AMENDED  
NYMNP  
- 3 SEP 2019

No. 10 SOUTH END - OSSTROTHERLEY  
PROPOSED ALTERATIONS & CONVERSION OF OUTBUILDINGS TO FORM ONE DWELLING AND ADAPTATIONS TO EXISTING DWELLING.  
DRNG 2019 PROPOSED PLAN  
SCALE 1:160 AT A2 - Aug 2019

PROPOSED GROUND FLOOR PLAN

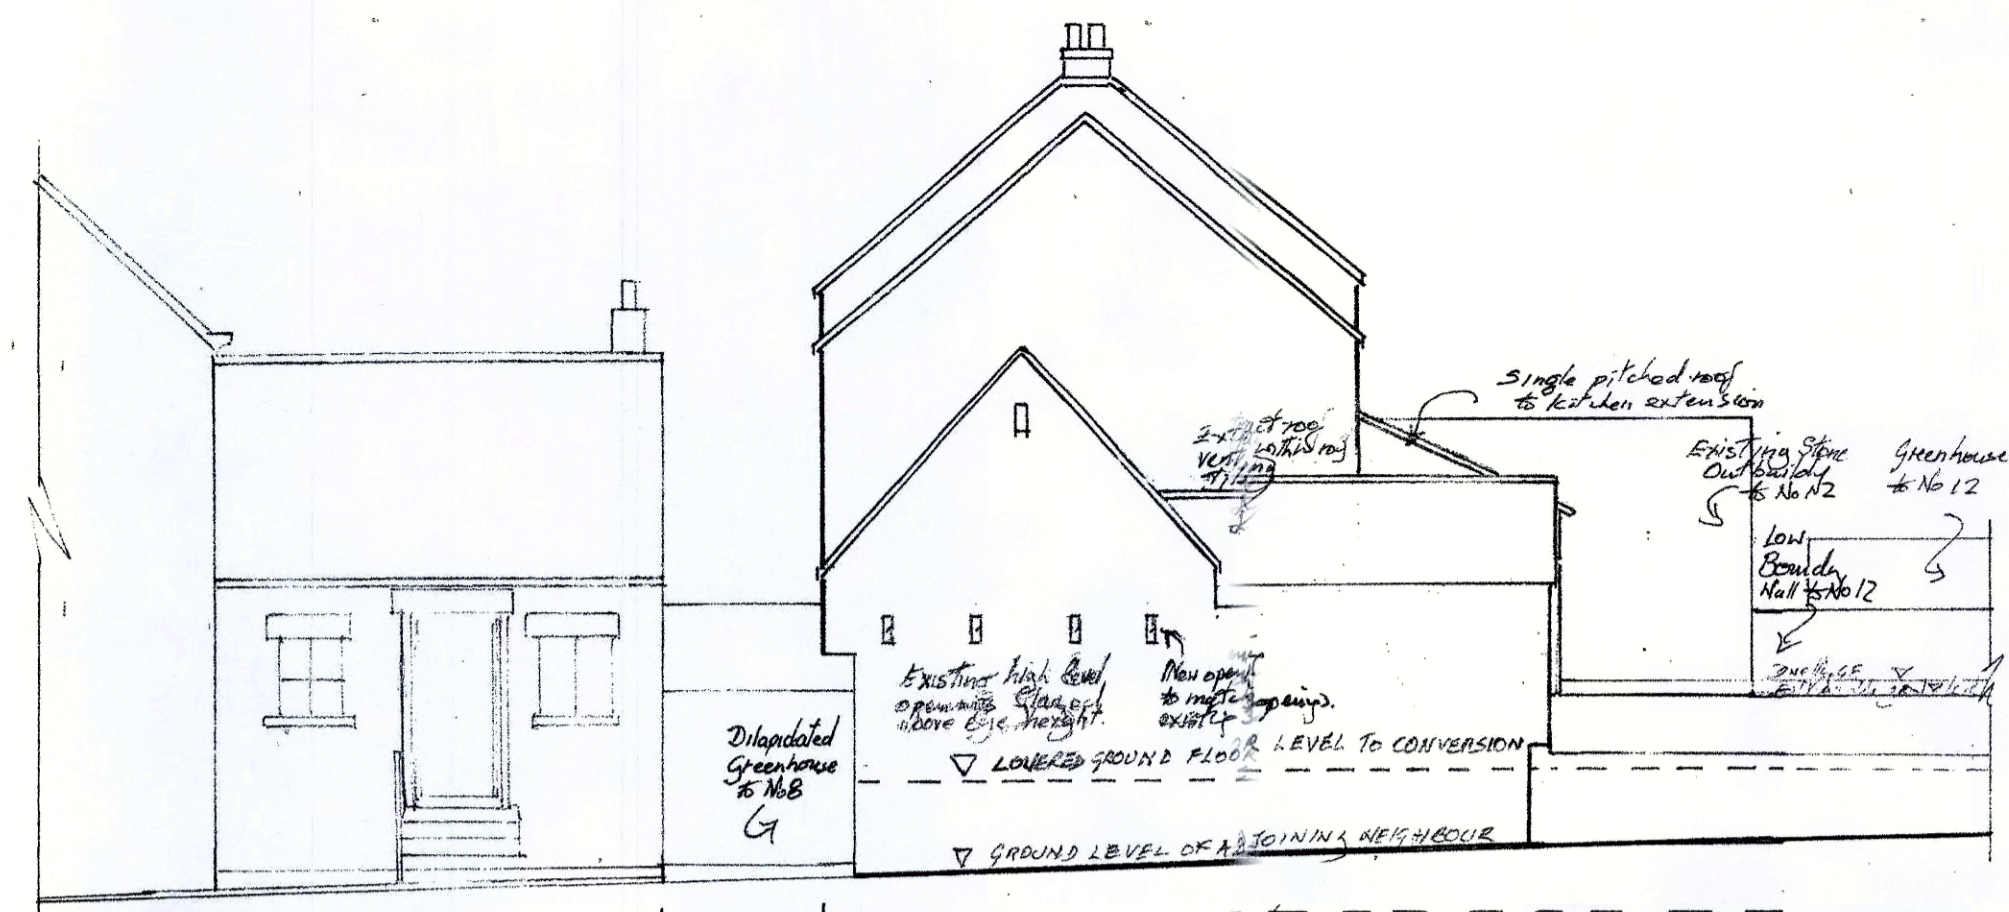
28 Sept 18 Rev A:  
As req -  
Floor level to proposed dwelling lowered to lowest outbuilding level.  
Roof height of front outbuilding reduced to one and a half stories  
Roof height of pigsty outbuilding lowered with lowest ceiling height at 2m above floor level.  
Front elevation - blocked up door retained.  
Kitchen and toilet area reduced.  
Pitch to pigsty roof retained and linked to mono pitch extension.  
Rear elevation windows - glazing bars removed, casements used.  
Gap between kitchen and outbuilding extension removed.  
External store shed added.

27 Mar 19 Rev B:  
As req -  
Unsound load bearing walls replaced in original position - realigned dwelling south wall - reduced garage to offset accommodation loss.  
Traditional pitched roofs reverted to hipped roofs with eaves height retained.  
West elevation now evidences original roof ridge abutting hipped roof.  
Outbuilding access retained and brought back into use.  
Full pigsty span and pitch of roof retained, eaves habitable height, openings glazed.  
New south facing window openings altered to vertical emphasis.  
Stonework to garage lintel repaired and lintel altered to match original height.

July 2019 Rev C:  
As req -  
South facing extensions removed to kitchen, dining and living area.  
Three bedrooms reduced to one and a half with roof height to outbuilding reduced from one and half storey to original one storey.  
First floor toilet facilities removed with stairs altered.  
Hipped roofs returned to traditional pitch  
Outbuilding extension replaced at 2m depth set back 300mm, timber framed glazed conservatory with lowered pitch. Four ventilation and light slots removed, roof vent added.  
Sth facing upper floor blocked in window reopened to form glazed window to bedroom.
